Informal Document GRSP-74-20
(74th GRSP, 4-8 December 2023,
agenda item 5)

UN R14: Proposal on Alternative Anchorage Positions

Two Possible Areas in Document GRSP/2023/28

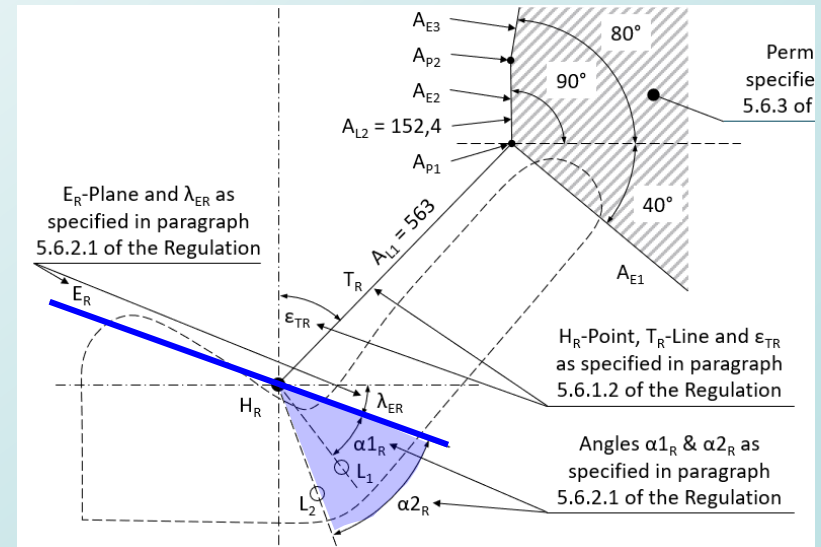
When moving the seat into the extended use position, the permitted area for lower anchorage points are either

- Not affected by the change

→ Permitted area will not change.
 $\lambda_{ER} = 0$

- Affected by the change

→ Permitted Area will change.
 $\lambda_{ER} = \text{change of cushion's inclination}$

Further Amendments

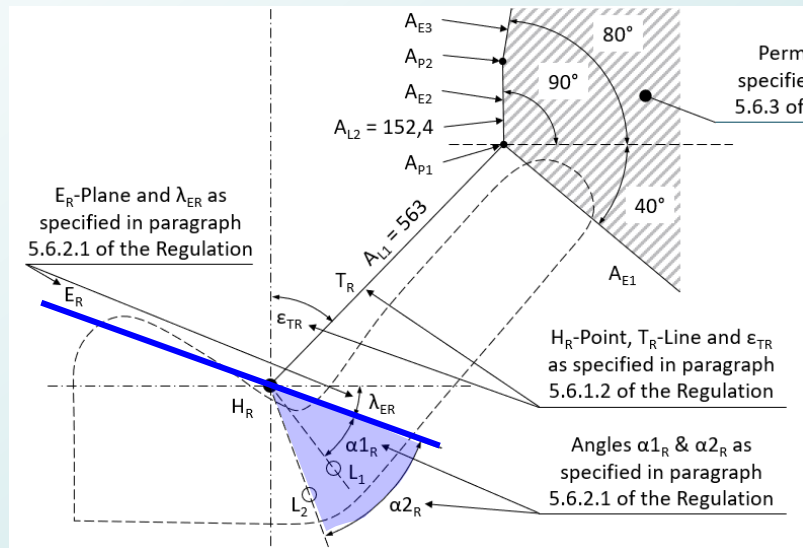
- It was brought to attention that there might be solutions, which will not have a dependency of the lower anchorage points on the seat cushion's inclination, but would need a tilted permitted area.
- In this case, the permitted area shall move by one third of the change in inclination of the seatback.
- This follows a study, where there was found such a dependency between the Torso and Pelvis angle.

→ Permitted Area will change.
 λ_{ER} = change of $\frac{1}{3}$ of the inclination change of the seatback
